TOWN OF WELLS, MAINE
PLANNING BOARD

Meeting Agenda
Monday, March 23, 2026, 7:00 PM
Littlefield Meeting Room, Town Hall
208 Sanford Road

The Grace Group, LLC, owner/applicant; Walsh Engineering, agent. Site Plan Amendment Application to divide the 8.15 acre property into two lots. The existing School use to remain within the existing building on 1.3 acres of land. Changes to parking, landscaping, stormwater and utilities proposed. The property falls within the General Business District and Rural District. The property is located at 526 Post Road and is identified as Tax Map 27, Lot 10. **Workshop completeness and determine public hearing**

Sheet No.:
C2.0

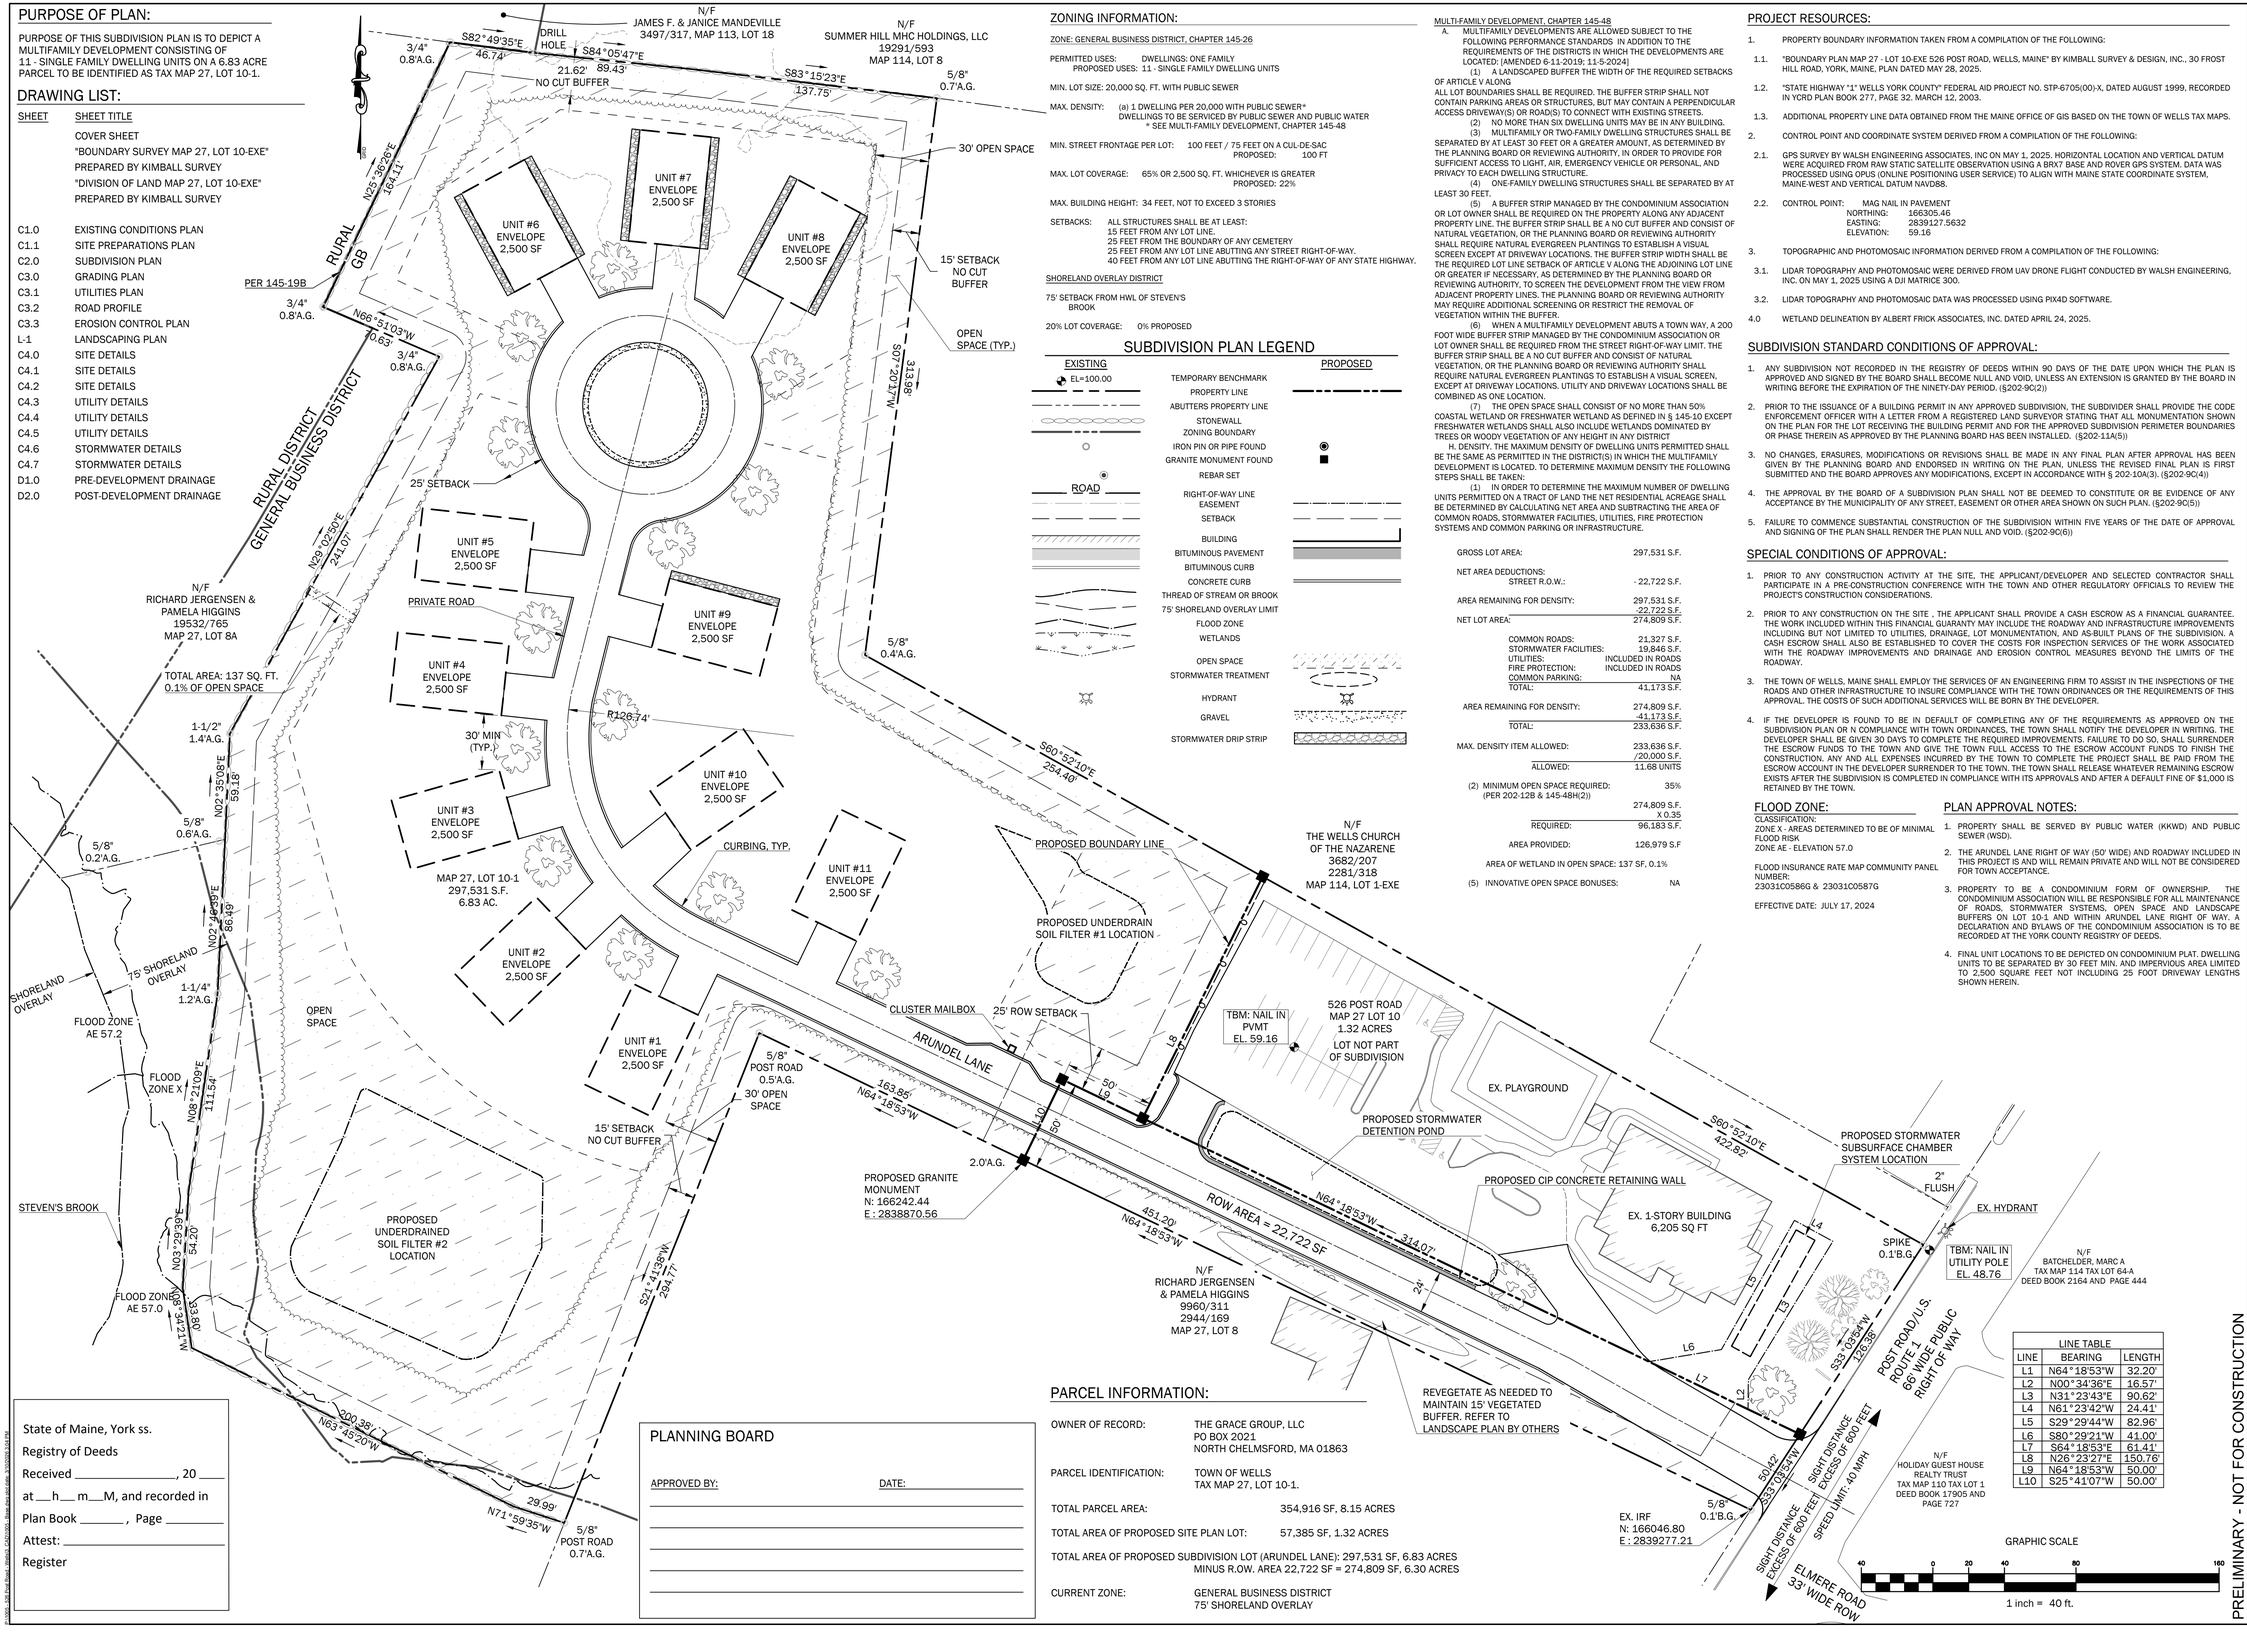
F.(6).a. [3]	Twenty-five feet from any lot line abutting any street right-of-way.	**Parcel does abut the Arundel Lane ROW. 25' setback to be identified.**	Y	C2.0	Proposed 25' setback off of Arundel Lane ROW has been added.
145-48	**PERFORMANCE STANDARDS - MULTIFAMILY DEVELOPMENTS**				
A.(1)	A landscaped buffer the width of the required setbacks of Article V along all lot boundaries shall be required. The buffer strip shall not contain parking areas or structures, but may contain a perpendicular access driveway(s) or road(s) to connect with existing streets	15' wide landscaped buffer along all lot lines noted. **Label corrections needed.** Arundel Lane roadway serving the multifamily development crosses the buffer required from the street ROW.	Y	All Sheets	Labels for the proposed 15' landscaped buffers for the multifamily development have been updated accordingly on all sheets.
A.(4)	One-family dwelling structures shall be separated by at least 30 feet.	**Single family dwellings shall be separated by a minimum of 30 feet. Measurements between the units on the plan appear to be 28 or 29', not 30'.** **Plan provided is not to scale.**	Y	All Sheets	Confirmation that all building envelopes are separated by 30 feet. Plans have been printed with correct margins to provide accurate scale.

ITEM NUMBER	DESCRIPTION	STAFF COMMENT 2/20/2026	COMMENT ADDRESSED	DRAWING / SHEET NUMBER	COMMENT RESPONSE 3/10/2026
F.(3)	Minimum street frontage per lot: 100 feet, which may be reduced to 75 feet for frontage entirely on a cul-de-sac	**The subdivision lot depicts 100' of street frontage on Arundel Lane ROW.**	Y	C2.0	No response necessary
F.(4)	Maximum lot coverage: 65% (20% within the Shoreland Overlay District) or 2500 square feet, whichever is greater, except that the maximum lot coverage shall be 40% of the entire lot on any lot that was legally created prior to January 1, 1994, if at least 75% of the lot is located within the Shoreland Overlay District	The 65% maximum lot coverage of the GB zone is noted on the plan. The proposed lot coverage is 22%. The 2,500 SF boxes on the plan are building envelopes.	Y	C2.0	No response necessary
F.(6).a. [3]	Twenty-five feet from any lot line abutting any street right-of-way.	**Parcel does abut the Arundel Lane ROW. 25' setback to be identified.**	Y	C2.0	Proposed 25' setback off of Arundel Lane ROW has been corrected.
